Request for Proposal, 18MCO532
In response refer to RFP No. 18MCO532 Addendum 1 (one)
September 14, 2018

MIDLAND COUNTY COUNTY ROAD 1160	DA PROJECT B001484.021
PIPELINE CAP DETAILS	SHEET 38

Paving, Grading, and Drainage Improvements to serve County Road 1160 - Phase I

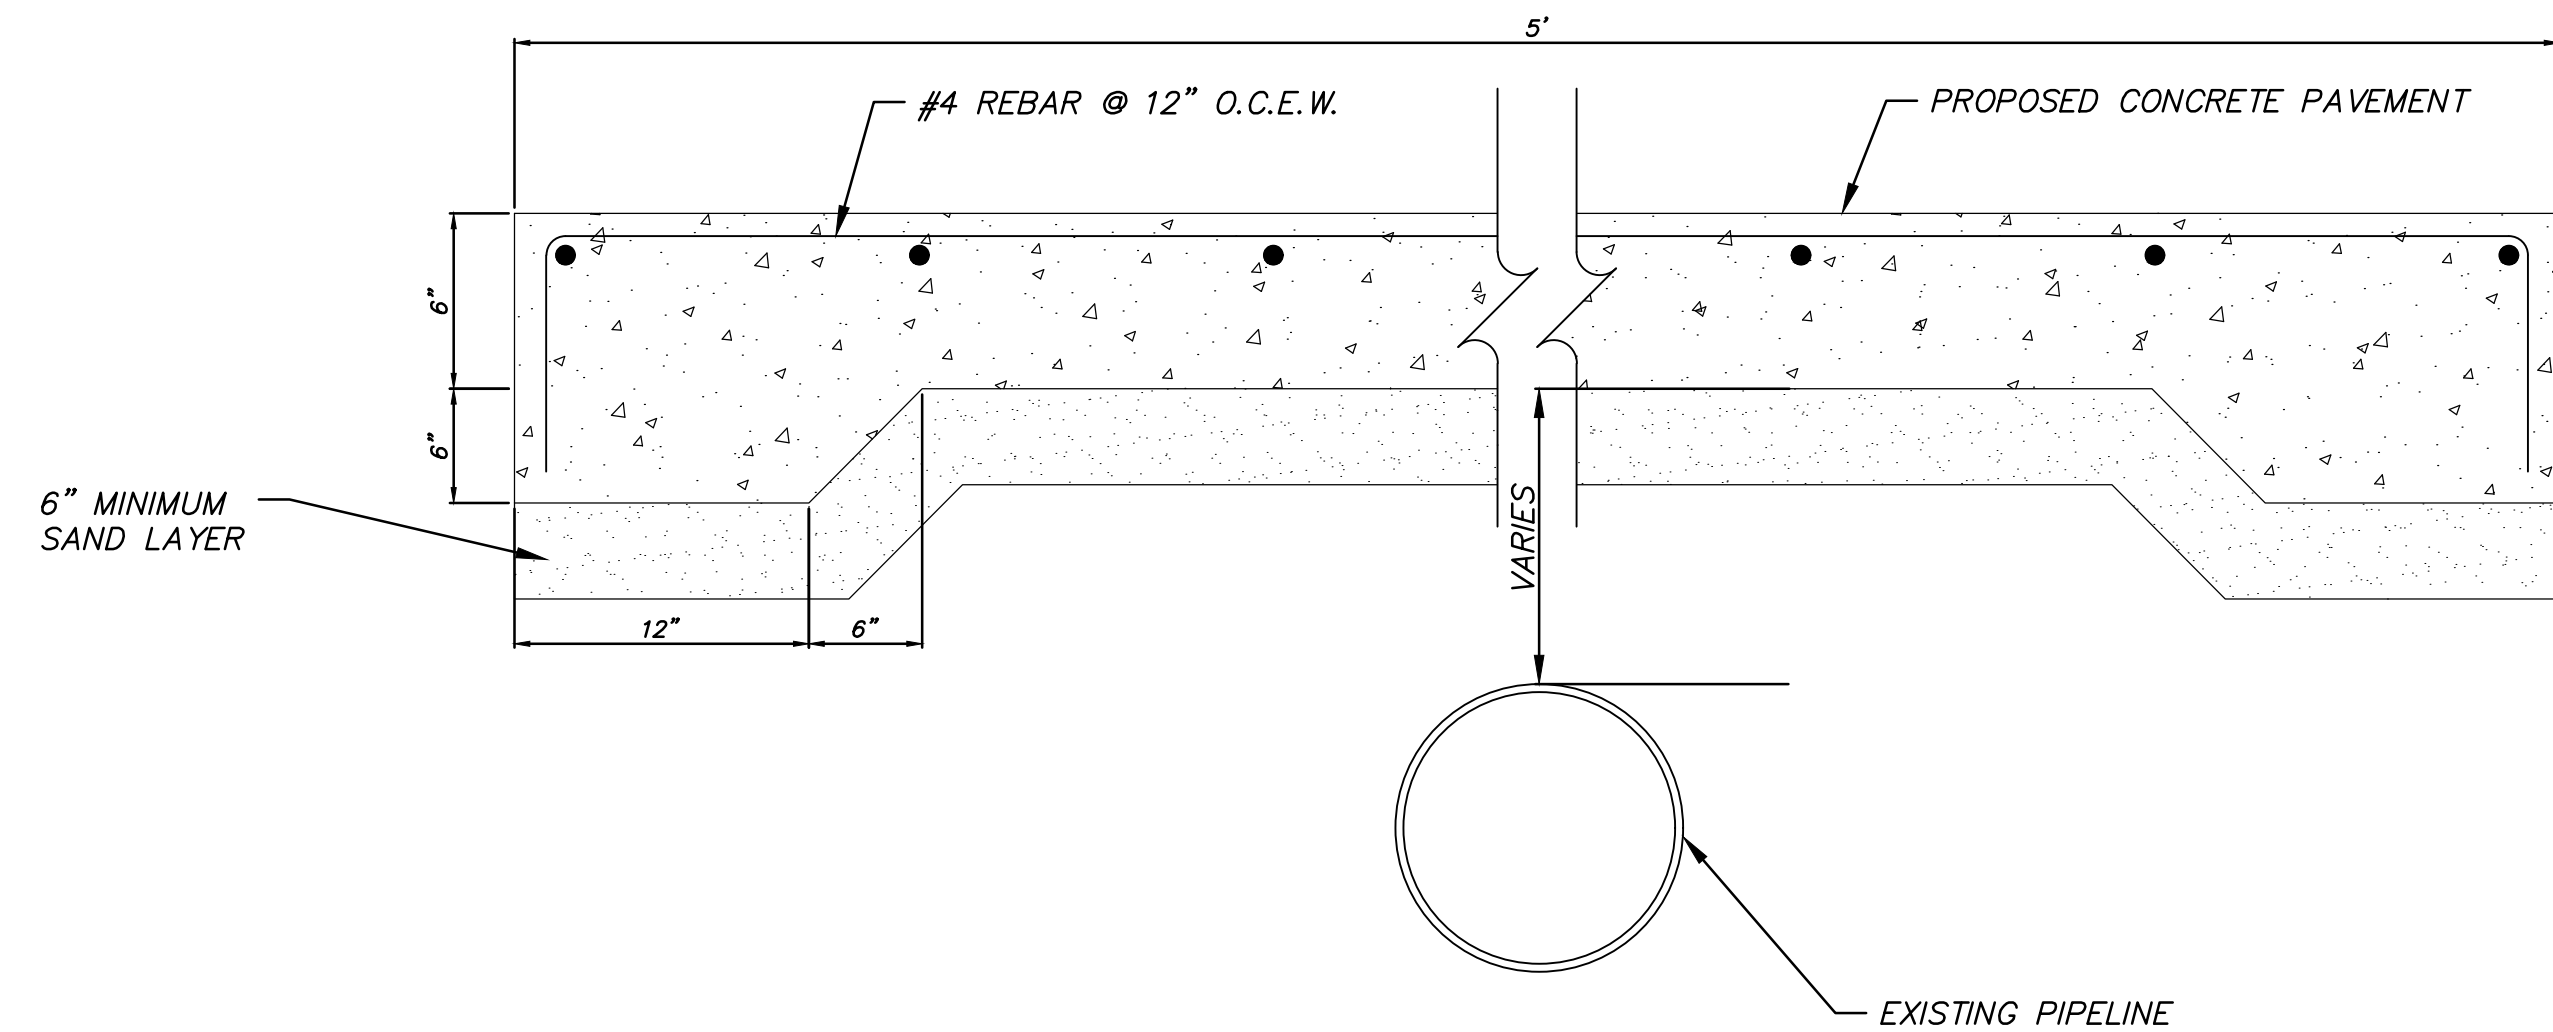
17. Removal of gravel driveways, 10 ea, is this in the excavation?
Yes, this quantity is included in the excavation.
18. Where is the pipeline cap located? $60' \times 5'/9 = 33.33$ sy, not 11 sy? Class A is 3000 psi, detail requires 3500 psi, what is required?
Please see the revised detail stating 3500 psi for concrete. Unit quantities revised per Addendum No. 1. The 11 each Pipeline cap quantity was determined based off survey data of location of pipelines and assumed pipeline depths. Final deliverable quantity may vary depending on actual pipeline depths determined by field locating during construction.

27. Removal of gravel driveways, 7 ea, is this in the excavation?
Yes.
28. Pipeline cap detail, Class A is 3000 psi, detail requires 3500 psi, what is required?
3500 psi. She sheet revision.

1. CONCRETE SHALL HAVE A MINIMUM OF 5 SACKS OF CEMENT PER CUBIC YARD AND A MINIMUM 28 DAY COMPRESSION STRENGTH OF 3500 P.S.I.
2. MATERIALS AND CONSTRUCTION METHODS SHALL CONFORM TO TxDOT STANDARD SPECIFICATIONS.
3. REINFORCEMENT SHALL BE #4 BARS AT 12" ON CENTER EACH WAY.
4. CONTRACTOR TO VERIFY BOTH VERTICAL AND HORIZONTAL LOCATIONS OF ALL GAS LINES BEFORE CONSTRUCTION IN THIS AREA.
5. WIDTH AND LOCATION TO BE BASED ON SLAB EXTENDED APPROXIMATELY 2'-6" BEYOND OUTSIDE PIPE ON BOTH SIDES.
6. CONTACT PIPELINE OWNER A MINIMUM OF 48 HOURS PRIOR TO WORKING IN THIS AREA.
7. NO LESS THAN SIX INCHES OF SAND OR EQUIVALENT CUSHION BETWEEN THE BOTTOM OF THE SLAB AND TOP OF EXISTING PIPELINE.

1	REVISE NOTE 1	JAS	9/20/18	JRA	DESIGNED
				JRA	DRAWN
				BIB	CHECKED
NO.	REVISION	BY	DATE
